# WOLF CREEK

NUCLEAR OPERATING CORPORATION

October 27, 2005

Subject: Docket No. 50-482: Revision to Technical Specification (TS) 1.1, "Definitions," and TS 3.4.16, "RCS Specific Activity"

FIGURE 3.4.16-1 (page 1 of 1)  
Reactor Coolant DOSE EQUIVALENT I-131 Specific Activity  
Limit Versus Percent of RATED THERMAL POWER

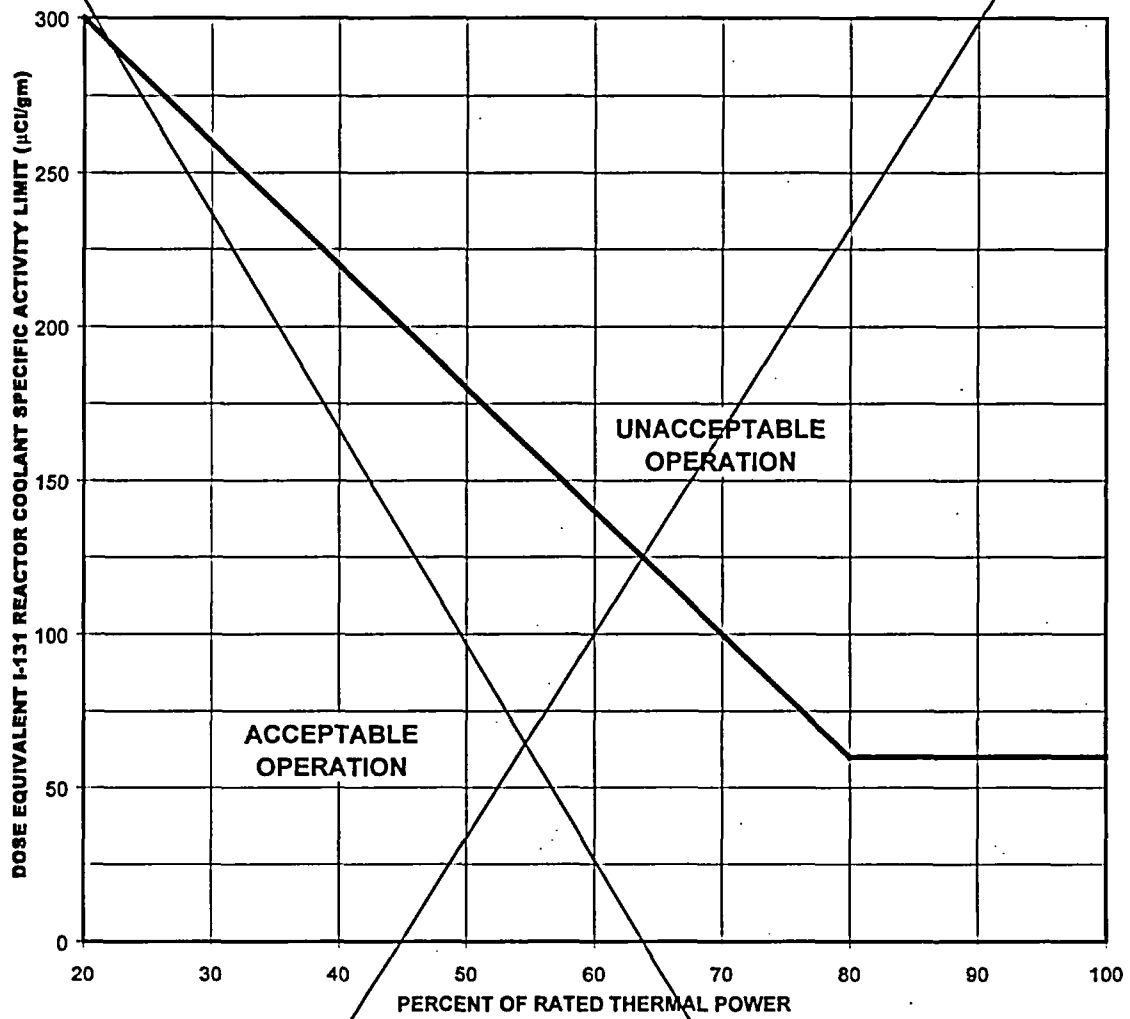
The current TS Figure 3.4.16-1, "Reactor Coolant DOSE EQUIVALENT I-131 Specific Activity Limit Versus Percent of RATED THERMAL POWER" would be deleted.

"Verify DOSE EQUIVALENT I-131 within the acceptable region of Figure 3.4.16-1."

DOSE EQUIVALENT I-131 in the unacceptable region of Figure 3.4.16-1."

TS 3.4.16 Required Action A.1 is modified to remove the reference to Figure [3.4.16-1] and insert a limit of less than or equal to  $60 \mu\text{Ci/gm}$  for DEI.

The curve contained in Figure 3.4.16-1 was initiated by the AEC in a June 12, 1974 letter from the AEC on the subject, "Proposed Standard Technical Specifications for Primary Coolant Activity." However, this letter does not provide any technical basis for the curve.

The Case 2 radiological consequence analyses for SGTR and MSLB accidents that take into account the pre-accident iodine spike do not consider the elevated RCS iodine specific activities permitted by current TS Figure 3.4.16-1 for operation at power levels below 80% RTP (i.e. DEI of  $60 \mu\text{Ci/gm}$  at 80% RTP increasing linearly to  $[300] \mu\text{Ci/gm}$  at  $[20]\%$  RTP). Instead, the Case 2 analyses assume a DEI concentration 60 times higher than the corresponding accident's Case 1 analysis assumption [ ,which corresponds to the  $60 \mu\text{Ci/gm}$  specific activity limit associated with 100% RTP operation as discussed in Section 3.1 above]. Therefore, TS 3.4.16 Required Action A.1 should be based on a limit of  $60 \mu\text{Ci/gm}$  to be consistent with the assumptions contained in the radiological consequence analyses. It is not expected that plant operation at reduced power levels would result in iodine specific activity levels that exceed the  $60 \mu\text{Ci/gm}$  upper limit defined for full power operation.

"Verify DOSE EQUIVALENT I-131  $\leq$  60  $\mu$ Ci/gm."

DOSE EQUIVALENT I-131  $> 60 \mu Ci/gm$ ."
